Countywide Transit Corridors Functional Master Plan

Appendix 14
Stormwater Management

Subject: Stormwater Management for BRT Corridors in Montgomery County:
Response to Comments

To: Larry Cole, M-NCPPC
From: Nimish Desai
CC: Michael Flood
Date: April 6, 2012
Subject: Stormwater Management for BRT Corridors in Montgomery County - Updated (DRAFT)

Figure 6: Illustration of Wet Swale
 Source: MDE SWM Manual

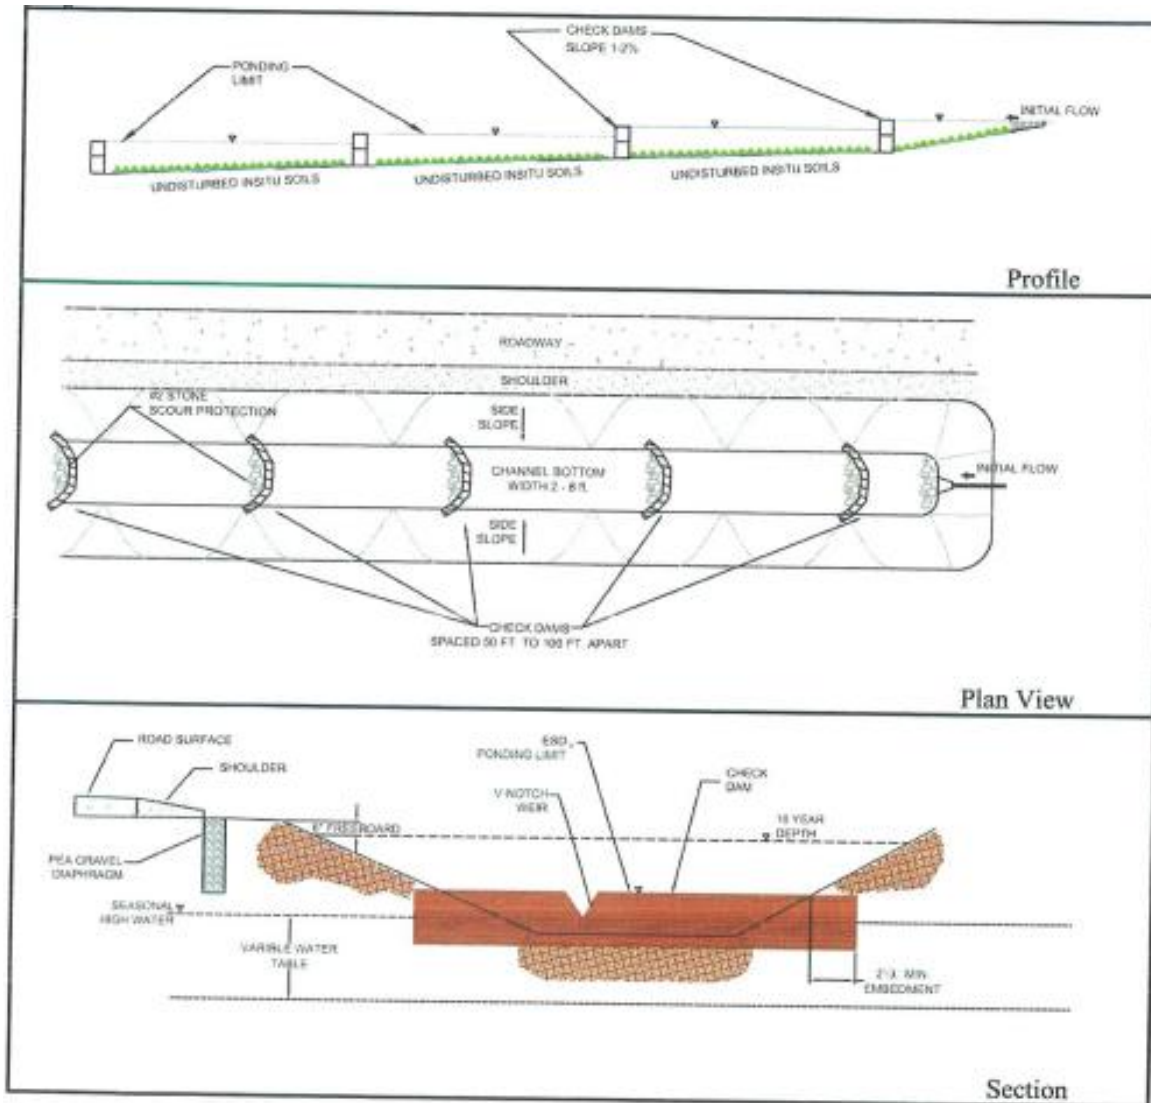
- Wet swales are not appropriate for the BRT line as the water table is not likely to be high enough in most areas and insects could be a nuisance.

PB Response: SWM facilities will be selected during final design depending upon the location of the alignment. The memo presents the different ESD options that can potentially be used along a BRT corridor.

Figure 8: SWM Typical Section using Water Quality Filter Strip
Source: PBNetwork, May 2009

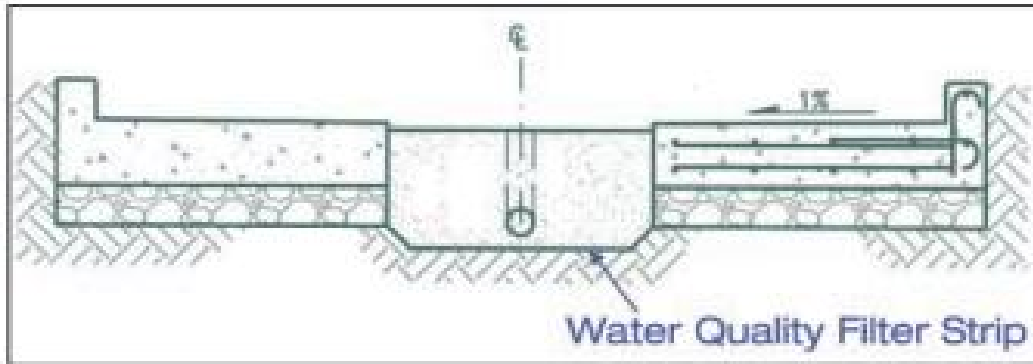
- Not a standard MDE approved practice (sand filters): May require additional testing.
 - M-NCPPC Response: MDE has not rejected “Green Streets”. A Green Street is a street with any stormwater treatment. MDE will approve a ‘Green Street’ if the treatment facility(s) (whichever ones they are) are sized correctly.

- M-NCPPC Response: A Green Street does not have to be or have a sand filter; it can have any approved stormwater treatment facility/device.

- Requires plant establishment which is difficult due to free-draining layer of sand
 - M-NCPPC Response: As noted above, a Green Street does not have to be a sand filter and thus planting does not have to be limited.

PB Response: Comment noted. To avoid confusion with any SWM treatment that can be accommodated within the streetscape, we have renamed the phrase “green street” to “water quality filter strip,” to accurately reflect the treatment being described. Although MDE has not rejected the idea of water quality filter strips, the feasibility and viability of the same is still being tested in several cities in US. Maryland Transit Administration is currently studying the concept for the Red Line project. The key to the concept of the water quality filter strips is that vegetation be maintained in the filter strips and that the filter media should allow free draining of runoff and not creating ponding. Also, further design guidance will need to be coordinated with the designers, Montgomery County and MDE.

PB Response: Agreed. The water quality filter strip can be of any material and does not necessary have to be a sand layer. The key to the concept of the green street is that vegetation be maintained in the filter strips and that the filter media should allow free draining of runoff and not creating ponding and create a traffic hazard. There are very limited choices of the approved ESD stormwater management treatment facilities that will qualify for this application.

PB Response: Please see response stated above.

Figure 9: Illustration of Permeable Pavements
 Source: MDE SWM Manual

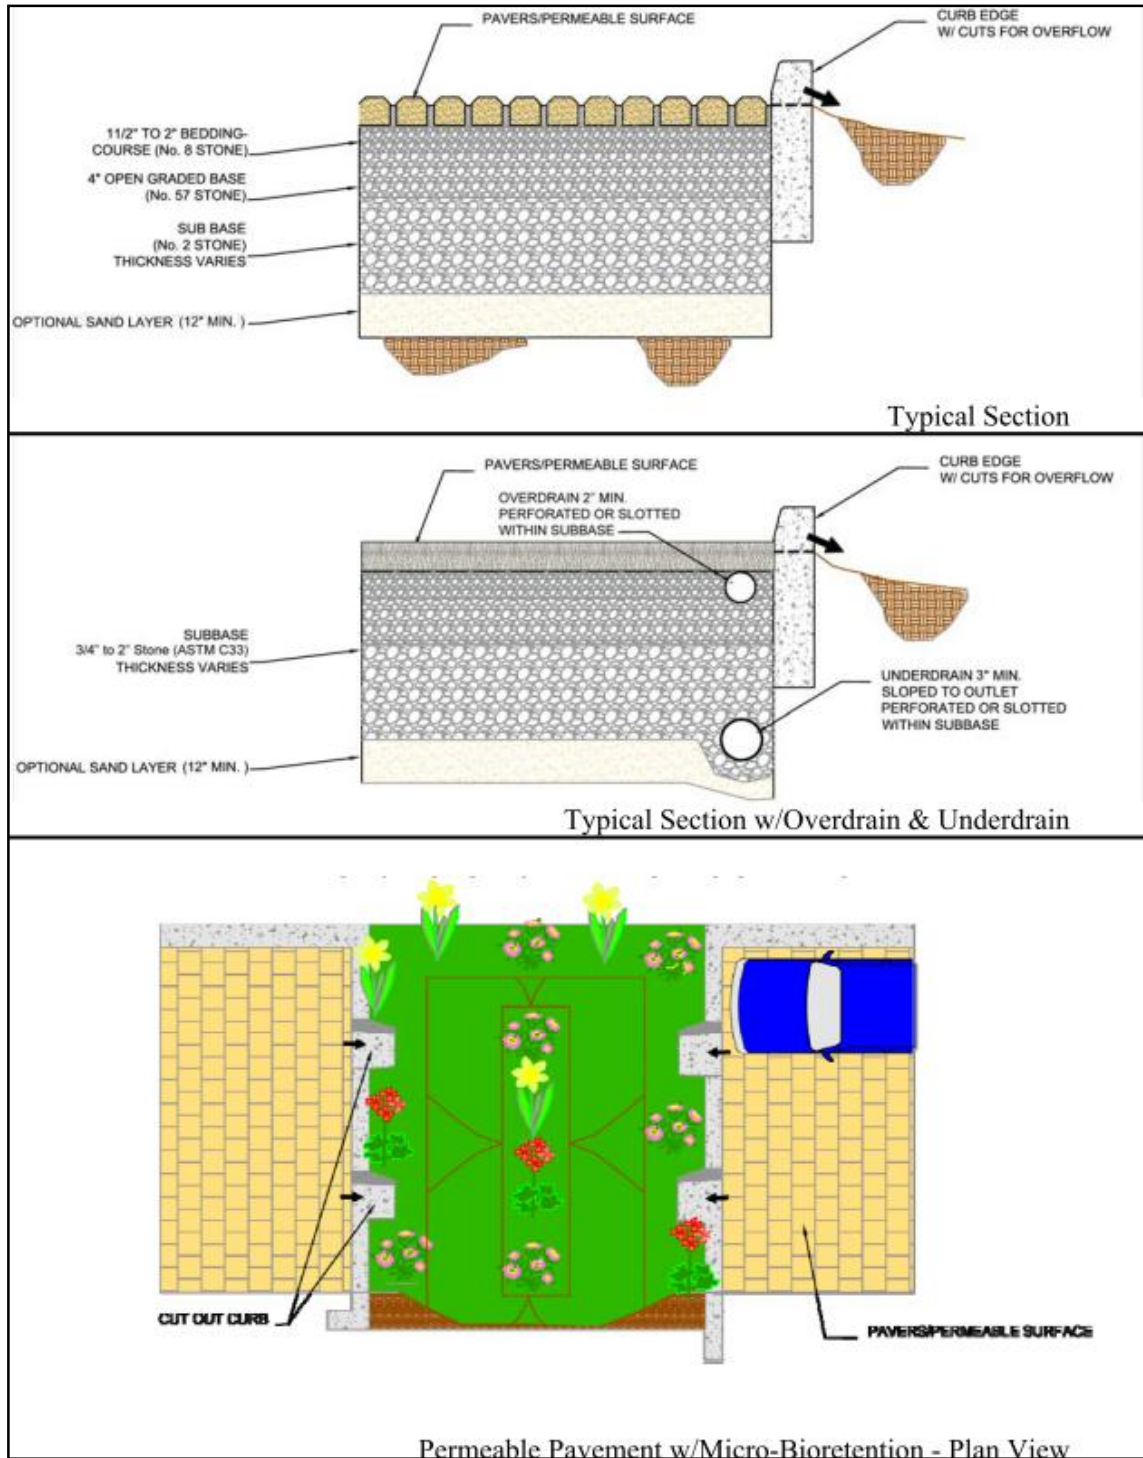
- Permeable pavement is recommended only in areas where the soils types are sandy or silty having hydrologic soil groups of A, B or C.
 - M-NCPPC Response: Soil types C and D drain slowly or not at all. These soil types are often found in compacted urban soils. In these situations soil types C and D does not preclude the use of permeable pavements. A routine practice is the use of an underdrain to which allow for water catchment, containment, and the slow release of water into the stormdrain system.

- The subsurface water table will help determine the stone reservoir thickness used.
 - M-NCPPC Response: The stone reservoir depth is determined by the storage treatment volume goals. However, if there is a high water table (not likely along the BRT line), then there would be a shallow reservoir or none at all.

- Maintenance is a major issue. Typically permeable pavements require regular vacuuming (usually every 6-8 weeks) to prevent sediments from clogging within the voids of the pavement.
 - M-NCPPC Response: Permeable pavements have come a long way. The void spaces are quite large now and many manufacturers recommend vacuuming once or twice a year. Some have even gone so far as to say no vacuuming is necessary (Flexi-pave).

- Cannot be used in areas having poorly drained soils or where the ground water table is high.
 - M-NCPPC Response: See response above pertaining to soil groups.

- During winter, there is a possibility of ice being formed in the voids of the pavement which can cause damage.
 - M-NCPPC Response: Multiple years of installation and testing has not shown this statement to be true.

PB Response: Comment noted. Chapter 5 of the MDE manual (Page 5.48 –Supplement 1)) states that permeable pavements should not be installed in HSG D or on areas of compacted fill. The MDE manual also recommends using perforated pipes in non-HSG D areas as an additional measure to ensure that the runoff is intercepted and conveyed to the storm drain system.

PB Response: Agreed. The stone reservoir depth is determined by the storage treatment volume goals as well as the ground water table. This will be determined during final design.

PB Response: Comment noted. Permeable pavements need periodic maintenance depending on its type and application. The type of permeable pavements to be used will be determined during final design and maintained as per the manufacturer's approved specifications.

PB Response: Comment noted. Chapter 5 of the MDE manual (Page 5.48 –Supplement 1) states that permeable pavements should not be installed in HSG D or on areas of compacted fill. The MDE manual suggests using perforated pipes to ensure that the runoff is intercepted and conveyed to the storm drain system.

PB Response: Comment has been removed. Chapter 5 of the MDE manual states that all permeable pavements shall be designed to ensure that water surface elevations for the 10-year storm do not rise into the pavement to prevent freeze/thaw damage to the surface. This should be confirmed with the manufacturer when selecting the surface during final design.

Figure 10: Illustration of Filterra Bioretention System

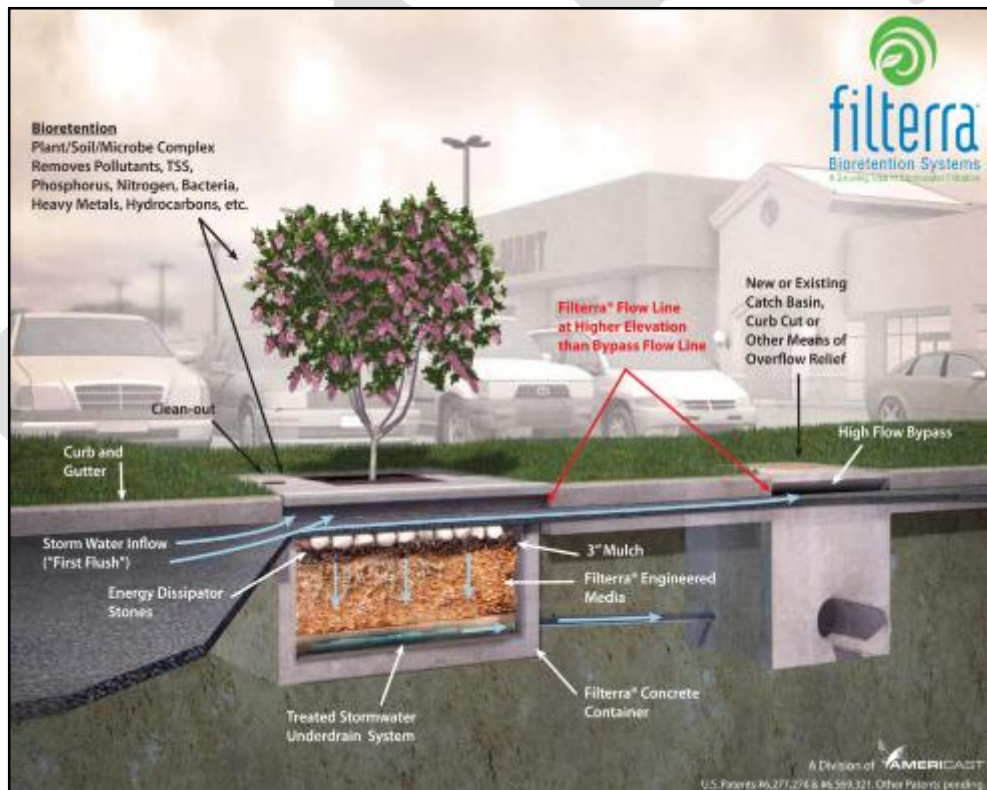
- M-NCPPC Response: A recent conversation with Brian Clevenger (MDE, Stormwater and Sediment Control) has stated that Filterra systems are an approved MDE stormwater treatment device.

- Maintenance needs to be provided by the manufacturer on a semi-annual basis.
 - M-NCPPC Response: Annual maintenance is required.

- Not a standard MDE approved practice.
 - M-NCPPC Response: See above comment pertaining to MDE approval.

PB Response: Filterra is an approved MDE device to treat 1” of runoff. However, during a presentation with Filterra in during late 2010, Filterra was still trying to work with MDE and get an approval so that their products could be used for ESD. The ESD guidelines suggest that the target rainfall may need to be as high as 2.6” and a minimum of 1” of runoff needs to be treated through ESD to MEP. If the entire target rainfall (P_E) runoff cannot be treated, supplemental facilities will need to be provided. PB is working on getting a response from Filterra as to their current status with MDE on the ESD criteria.

PB Response: Comment agreed. This will be confirmed during our coordination with Filterra.

PB Response: Comment noted. Filterra is manufactured device and not a traditional standard SWM device.
